Date: 17/12/2024
Your Ref: APP/X5210/W/24/3354411 &
APP/X5210/H/24/3354412
Our Ref: 2024/3309/P & 2024/3440/A

**Town and Country Planning (Control of Advertisements) (England) Regulations
2007, Town and Country Planning Act 1990
Appeals by Urban Innovation Company (UIC) Ltd
Site Address: Pavement Outside The Holborn Hotel on the North Side of Theobald's
Road, at the Junction with Old Gloucester Street, London, WC1B**

I write in connection with the above appeal against the refusal of planning permission and advertisement consent (Ref. 2024/3309/P & 2024/3440/A) for the **Installation of a Pulse Smart Hub with integrated digital screens and emergency functionality including provision of defibrillators and Display of illuminated content on digital screens integrated within new communication Hub.**

Image 5 – showing approved tables & chairs zone for hotel adjacent to appeal site (extract)

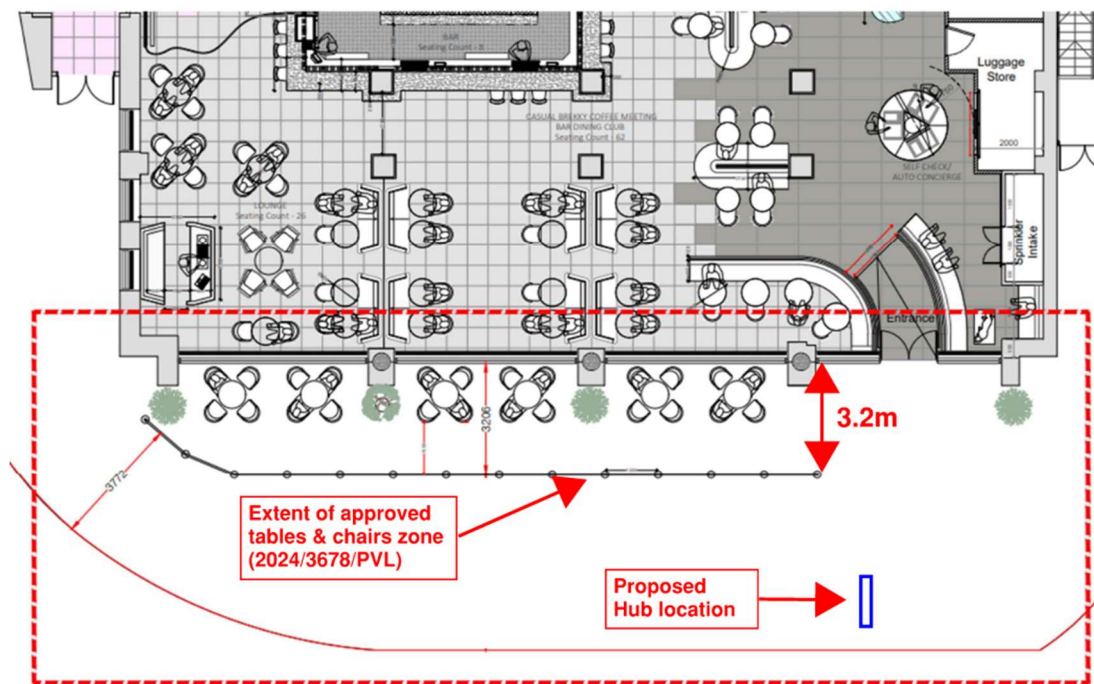
- 7.5 The approved tables and chairs zone (ref. 2024/3678/PVL) as shown in Image 5 above measures 3.2m, and as such, has a significant impact on the amount of pavement space available for pedestrian movement. As a result of this, and taking into account the appeal proposals to site a hub structure in this location, the available effective footway would be reduced to approximately 3.5m.

- 7.6 It is also noted that the Planning Inspector previously took the view that the appeal site could reasonably be claimed to be within the street furniture zone along this part of the footway. However, as noted above, the Appellant's plans as part of the current appeal for a proposed hub structure fails to show any contextual street items or furniture.

Image 6 – comparison of different communication kiosks/hubs (proposed hub structure in red)

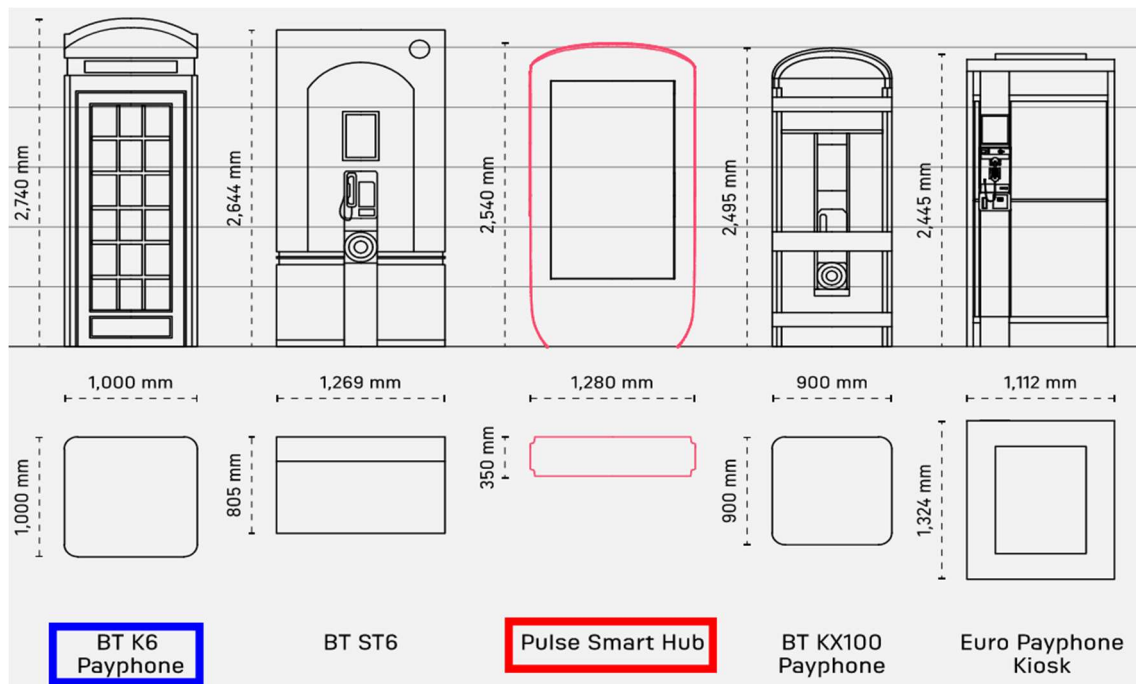
- 9.11 Whilst the proposed hub structure is shown in Image 6 above as having a smaller footprint than, say, a traditional red telephone box, this is primarily through a difference in depth rather than in width. Any difference therefore is not something that would be experienced by a pedestrian as the large width and profile of the proposed structure would be most noticeable and prominent to the pedestrian on approach, restricting their views and visual amenity in this context.

- 9.12 Furthermore, it is emphasised that there is no kiosk or hub of any kind in situ at the appeal site, and therefore, the Appellant's comparison of footprint dimensions with a traditional telephone box (or indeed any other communications kiosk/hub) is considered to be mainly irrelevant as the appeal proposals are not for a replacement structure, but rather would introduce a new item of street furniture to an area of public highway that is presently open and uncluttered by large or bulky items.

Image 9 – showing proximity of proposed hub structure (blue) to a signal-controlled pedestrian crossing and road junction with Old Gloucester Street (extract drawing)

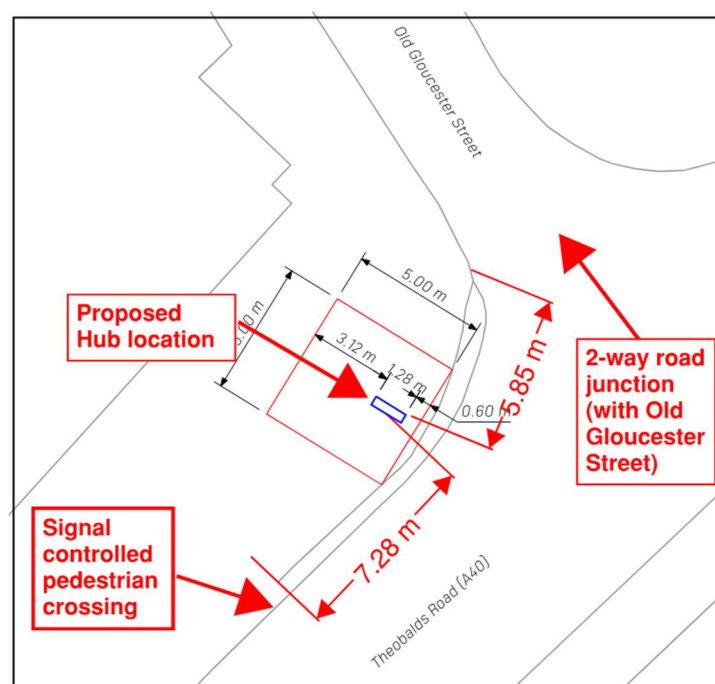
- 9.34 Images 7 and 8 above indicate that the proposed hub structure (with integrated digital advertising screens on both sides) would be installed within approximately 8m of a busy signal-controlled pedestrian crossing located to the south-west, contrary to the above Transport for London guidance. This degree of proximity is also shown in Image 9 below which has been scaled and measured from the Appellant's submitted drawings pack.

- 9.35 The proposals would therefore introduce a significant distraction to pedestrians attempting to use the crossing given the close proximity of both in relation to each other, by virtue of the appeal structure's size, location, illuminated displays and orientation. The appeal proposal would also lead to a distraction for road users for the same reasons, particularly motor vehicles or cyclists approaching the crossing in an eastbound direction along Theobald's Road.

- 9.36 The situation would be compounded given the proximity of the proposed illuminated advertisement screens to the 2-way traffic junction of Theobald's Road and Old Gloucester Street which is located within approximately 6m of the appeal site to the north-east. The large illuminated advertisement screens as proposed would not only provide a distraction to motorists and cyclists alike when attempting to turn left (north) into Old Gloucester Street from the junction with Theobald's Road (and vice versa, when attempting to enter Theobald's Road), as can be seen from Image 8 above, but would also impair clear views given the size, bulk and solid appearance of the proposed hub structure on which illuminated screens would be integrated and displayed.
